Public Service of New Hampshire

Subject: Seabrook Station Control Room Design Review

SEABROOK STATION

CONTROL ROOM DESIGN REVIEW

Procedure OS1013.05 RHR Shutdown

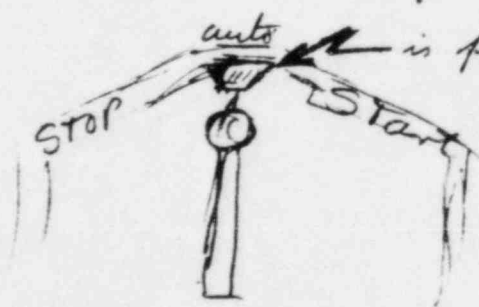
- 1) Step 7.3.1.1 There is no positive indication for HCV 606 closed (only dial indicator on the flow control dial) Flow meter above also not an indicator
- 2) Step 7.3.1.2 Labeling on FCV 610 pump should say Mini not Main flow (Pm Strm)
- 7.3.1.4 Panel B RCV-22 + 23 labels are not consistent with Procedure (loop suction valves)

3) FCV-608 Procedure calls for Auto in Step 7.3.1.6 but label is not marked auto (there is a module position)
